MEMORANDUM

SUBJECT: **Committee of Adjustment Variance Application (MNV)**
336 Main Street North, Markham Village Heritage Conservation District
Proposed two-storey rear addition with integrated garage

FILE: A/057/21

Proposed East (Primary) Elevation

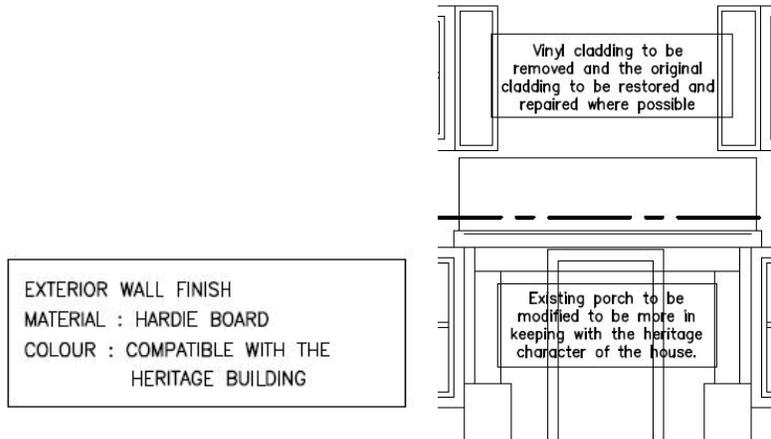
- See attached policy/guideline checklist (Appendix ‘B’) for new construction in the MVHCD as it relates to Type B properties.
- The conceptual elevation drawings submitted in support of the variance applications are generally supported, and have been refined in response to comments received from Heritage Section staff. As noted above, the relationship between the proposed addition and the existing dwelling ensures the continued prominence and three-dimensional legibility of on-site and adjacent heritage fabric. The restoration scope outlined in Appendix B of this memo will return the existing dwelling to a more historically-accurate condition, improving its contribution to the heritage character of the MVHCD.
- Staff suggest that the Committee may wish to delegate review of the submitted site plan application.
